10CFR21 NOTIFICATION LETTER

Subject: 10CFR21 Notification for Ashcroft 2-1/2" & 3-1/2" 1009, 63mm 2008, 63mm & 100mm 1008 Industrial Gauges, Weksler 3-1/2" Regal Gauges

PRODUCT ADVISORY LETTER

**Ashcroft® 2½” and 3½” 1009, 63 mm 2008,
63 mm & 100 mm 1008 Industrial Gauges, Weksler 3½” Regal Gauges:**

Figure 1 – C-type Bourdon Tube Assembly with Tip Details

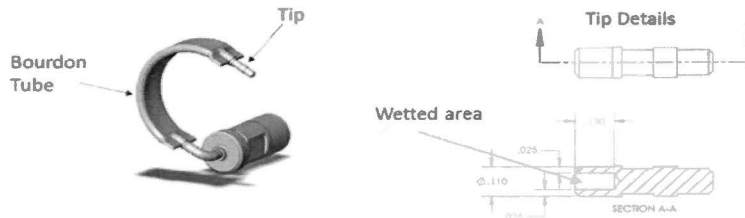
This letter is to alert you to a potential error in the tip material used on certain models of Ashcroft® Model 1008, 2008 and 1009 pressure gauges. We have determined that due to a supplier issue, 304SS tip material may have been supplied on some 1008, 2008 and 1009 gauges instead of the specified 316SS material. The gauges in question were shipped from October of 2017 through October 2019. (PLEASE NOTE: Bourdon tube material for all gauges was supplied with the correct 316SS material.)

In certain applications the 304SS tip material (see figure 1 below) may be subject to accelerated oxidation or degradation, resulting in the potential release of process media. However, no detrimental effects are expected in non-corrosive applications (i.e. water with neutral, oils/hydraulic fluids, non-corrosive gasses such as air and nitrogen, anhydrous ammonia and ammonia refrigerant). For additional corrosive information, please refer to our [Ashcroft Corrosion Guide](#).

These pressure gauges can be returned for replacement. Please contact your Ashcroft supplier or go to <https://sales.ashcroft.com/rma-form> to obtain an RMA and information on how ship the gauges back to Ashcroft.

Figure 2 –Date Code Label

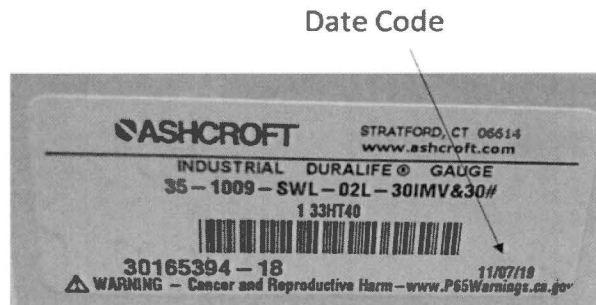
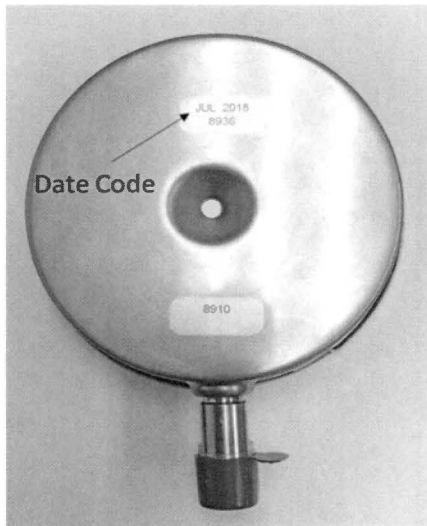
The date code can be found on a label on the back of the gauge with the month and year of manufacture or the gauge box (see figure 2).

Figure 3 – Visual Identification of 1008, 2008 and 1009 gauges

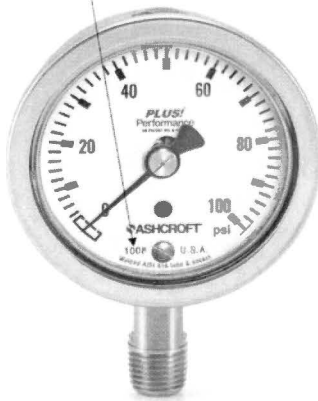
(See figure 3 for visual identification of gauge models and figure 4 for other pressure units)

2½" 1009SW or
3½" 1009SW Gauges

2½" 1009AW or
3½" 1009AW Gauges
are not part of the
product advisory
